Part 21 Report No: P21-04302015, Rev. 1

Subject: **Update** - Report of potential 10CFR Part 21, Allen Bradley Timing Relay Model 700RTC – NRC Event Number 51030, Accession Number ML15134A016

Figure 2 - New design circuit board and CPLD that replaced the original component.

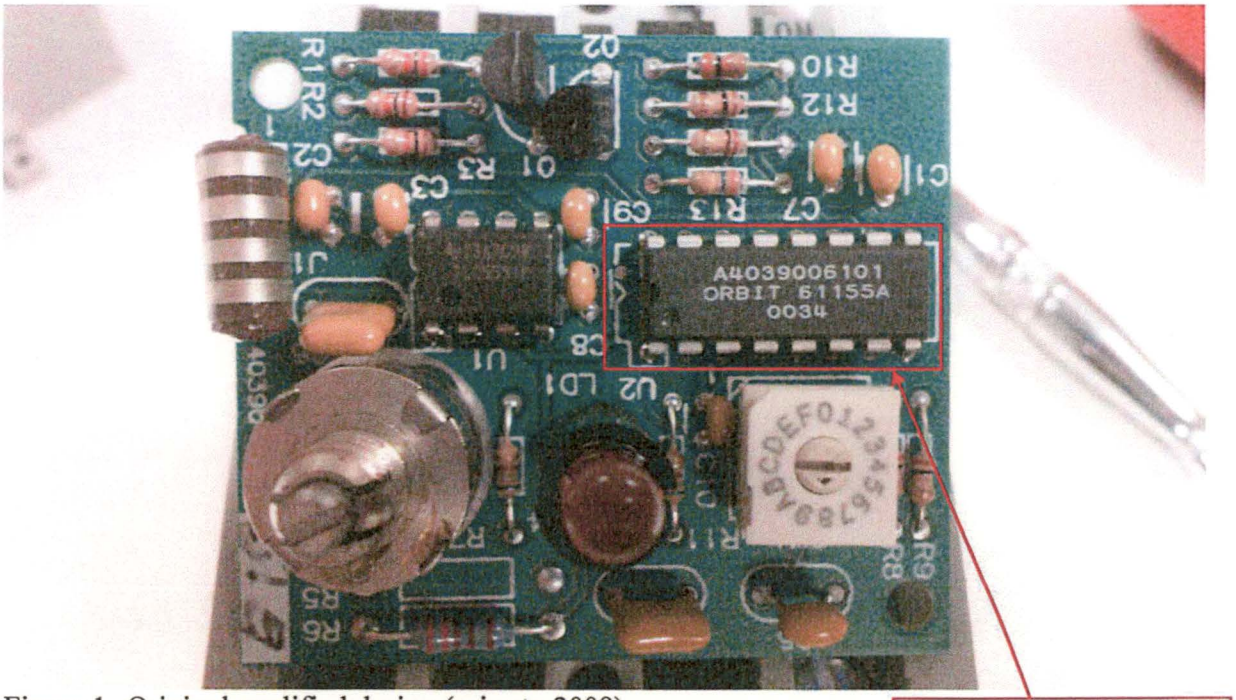
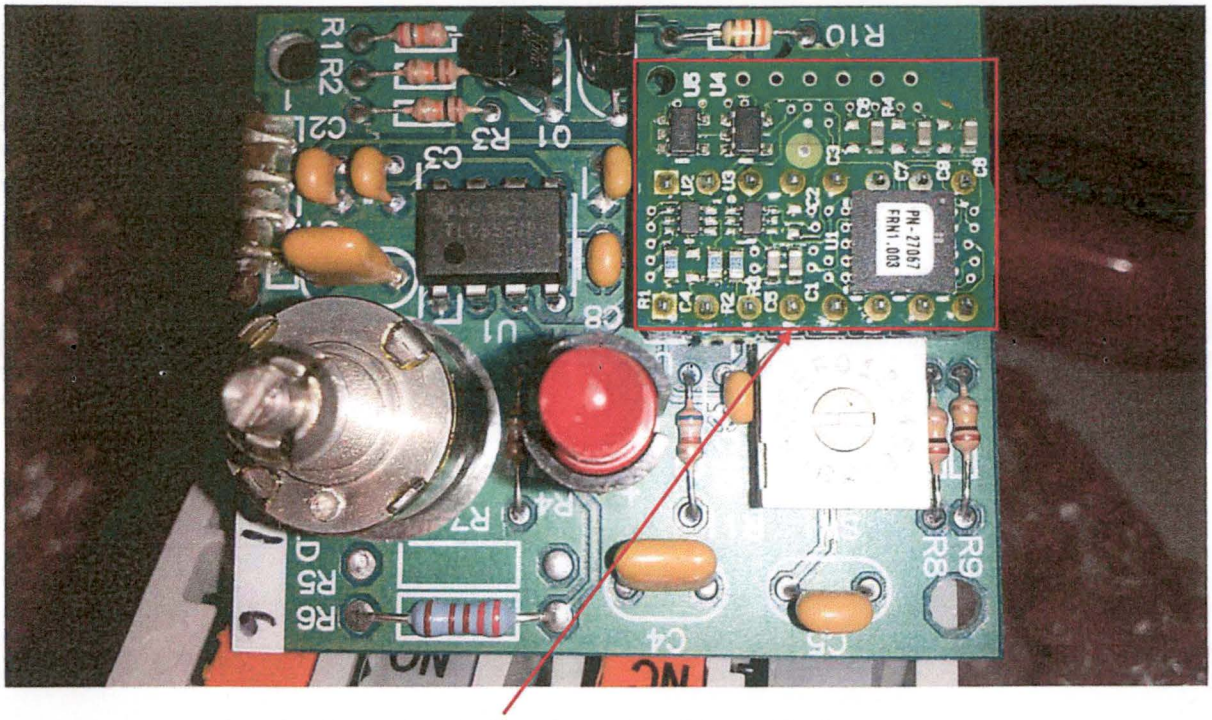
Between 2009-2010, Allen Bradley made a design change without changing the part number of the commercial relay or providing any documented evidence of a design change. The manufacturer specification data sheets maintain the classification that the relays are "solid state", which would imply that there are no digital devices installed in the relay. However, after inspection of the internals of the timing relay (Figure 2), it has been identified that the unit does contain a CPLD which meets the definition of a digital device under the guidance of NEI 01-01. See Figures 1 and 2 below:

Figure 1- Original qualified design (prior to 2009).
Relays supplied prior to 2009 are not affected by this issue.

The results were satisfactory with exception of the following condition: During Conducted Susceptibility CS114 onto the power lines, with the timing circuit in operation, the timing contacts exhibited chatter in the range of 2.6 MHz to 20.3 MHz. The unit requires a ferrite to be installed onto the input power lines of the relay with 3 turns through the ferrite core. In this modified configuration, the relay was not susceptible to Conducted Susceptibility and successfully passed the required test per CS114.

The relays are dedicated for generic application usage in timing applications. The specific plant application(s) is unknown by NLI. The EMC qualification of the relay is dependent on the installed configuration and location in the plant. The plant should evaluate whether the installed relays are subjected to the specific EMI/RFI condition Conducted Susceptibility CS114 between the frequencies of 2.6 MHz to 20.3 MHz identified above.
